PRODUCT CHANGE NOTIFICATION

Product Category REELSMART **20210520-1**

Product Group TIES AND TERMINALS

ISSUE DATE: 11-Jan-21

Photos/Drawing (where applicable)

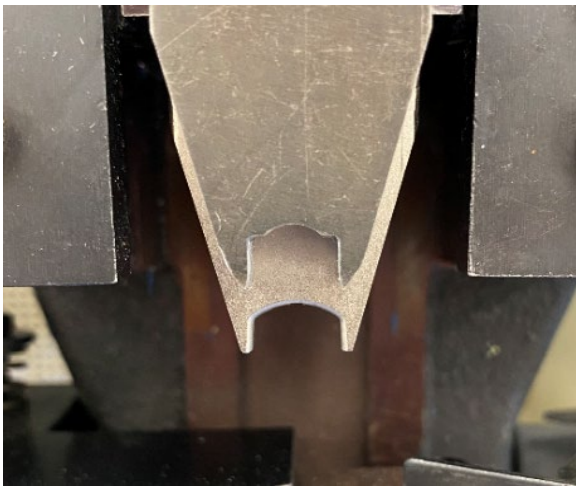
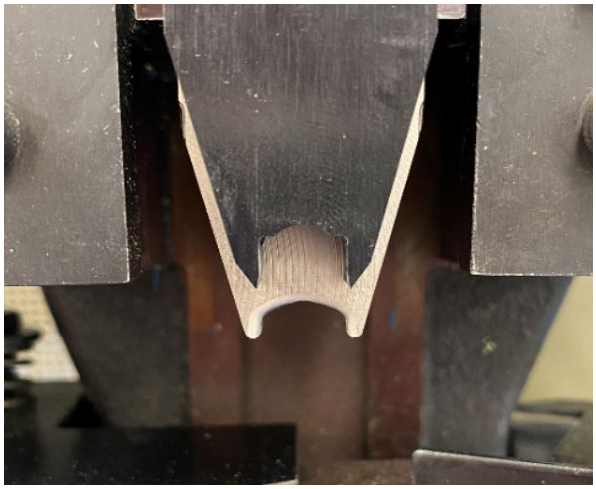
A change has been made to the upper crimp die of CD-800-3 (orderable component: TD13475C06) that is a used with the CA-800EZ ReelSmart applicator. The side walls of the crimp die have been shortened by 0.05 inches to optimize the crimp performance. This change will not affect the product's compliance to industry standards.
